Access Compliance Report

Public Rights-of-Way

(Pedestrian Signals)

Intersection ID: N/A	Main Street:	Cross Street: N/A	Location: N/A
ADA ID: A5A323E67172	Signal Type: One Push Button-Non APS	Overall Compliance: No	Severity Score: BTN 1: N/A BTN 2: N/A No BTN: N/A
Codes/Mitigation Info/Possible Solution		Field Measurements/Component Compliance

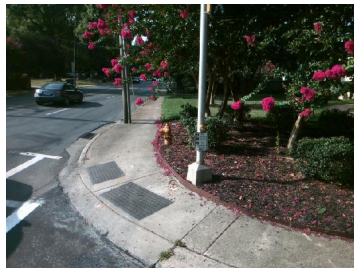
Possible Solutions: Provide Push Button Extension. Remove and Replace Clear Space.

PROW/ADA: R404.2, R404.3, R406.2
